RE: 2700495 - LIPSCOMB EAGLE - LOT 20 TC

Job	Truss	Truss Type	Qty	Ply	LIPSCOMB EAGLE - LOT 20 TC	T25385748
2700495	T10	HIP	1	1	Job Reference (optional)

## REPAIR(S) REQUIRED

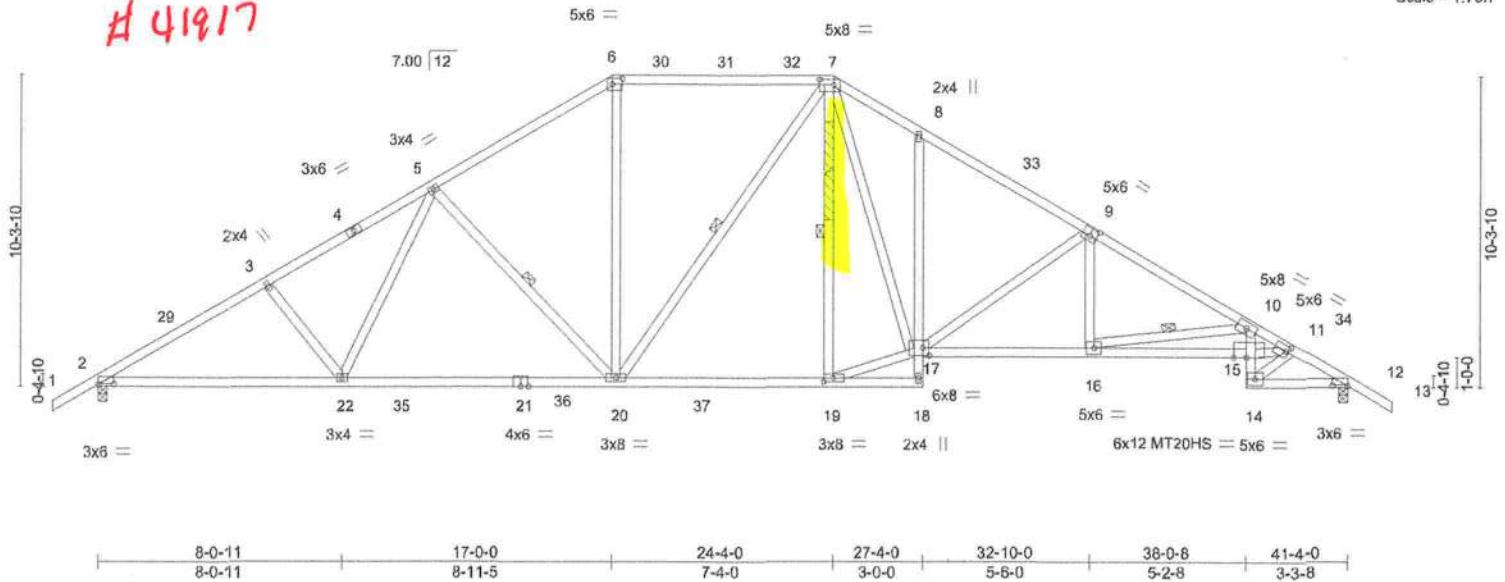
- 1) Repair Condition: web has 0-3-0 long break centered at 2-10-5 below joint 7.
- 2) Apply 39" long 2x4 SP No.2 scab to front side(s) of truss centered on damage located 2-10-5 below joint 7 with 2 row(s) of 10d (0.131"x3") nails spaced 2" o.c. from front face. Minimum 0-3-0 end distance.
